Access Compliance Report

Public Rights-of-Way

Intersection ID: 48454	Main Street: RED_RUST_LN	Cross Street: GOLF_LINKS_DR	Location: SE
ADA ID: D1F40AF1A88C	Ramp Type: BlendTrans1	Initial Pass/Fail: Fail	Overall Compliance: No
Severity Score: 1.25			
Codes/Mitigation Info/Possible Solution		Field Measurements/Component Compliance

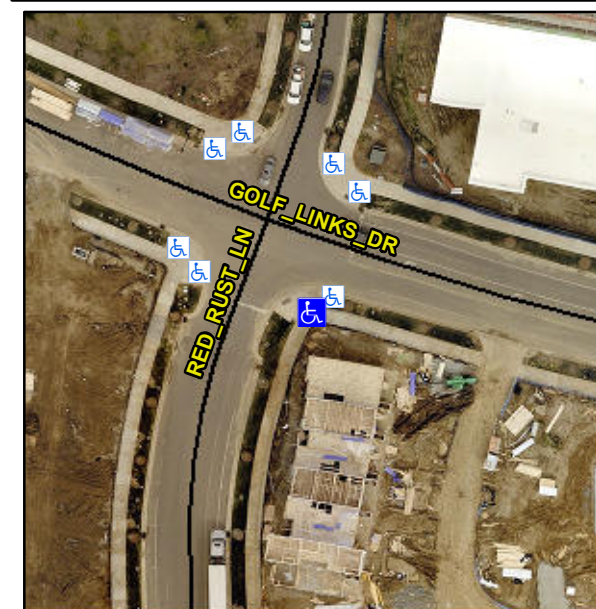
Not Found, R304.5.3

Compliance	Description	Data	Compliance	Description	Data
N/A	Ramp Length (in)	149.0	Yes	BlendTrans Slope (%)	4.1
Yes	Ramp Width (in)	60.0	No	BlendTrans XSlope (%)	4.2
N/A	Flare Type LT	N/A	N/A	Flare Type RT	N/A
N/A	Flare Slope LT (%)	N/A	N/A	Flare Slope RT (%)	N/A
N/A	Flare Traversable LT?	N/A	N/A	Flare Traversable RT?	N/A
N/A	Landing Length (in)	N/A	N/A	DWS Provided?	N/A
N/A	Landing Width (in)	N/A	N/A	DWS Contrast?	N/A
N/A	Landing Slope (%)	N/A	N/A	DWS Length (in)	N/A
N/A	Landing X Slope (%)	N/A	N/A	DWS Full Width?	N/A
N/A	Landing Curb? (Y/N)	N/A	N/A	DWS Offset (in)	N/A
N/A	Shared Landing?	N/A			
N/A	Gutter Ponding?	N/A	N/A	Gutter Slope (%)	N/A
N/A	Gutter Lip Ht (in)	N/A	N/A	Gutter X Slope (%)	N/A
N/A	Painted X Walk1?	No	N/A	Painted X Walk2?	N/A
	X Walk 1 Direction	To W		X Walk 2 Direction	N/A
	X Walk 1 Width (in)	N/A		X Walk 2 Width (in)	N/A
	X Walk 1 Slope (%)	0.0		X Walk 2 Slope (%)	N/A
	X Walk 1 X Slope (%)	2.5		X Walk 2 X Slope (%)	N/A

N/A	Ramp inside XWalk1?	N/A	N/A	Ramp inside XWalk2?	N/A
	Road Slope (%)	2.5		Clear Space?	N/A
	Road X Slope (%)	0.0	N/A	Clear Space to XWalk (in)	N/A
N/A	Any Obstructions?	N/A	N/A	Storm Grate/Utility Hazard?	N/A
	Obstruction Type			Storm Grate/Utility Type	
		N/A			N/A
			Yes	Surface Condition? (G/P)	Good
			No	Curb Slope (%)	10.6

Remove & Replace Curb Ramp With Two New Directional Ramps or Equivalent.
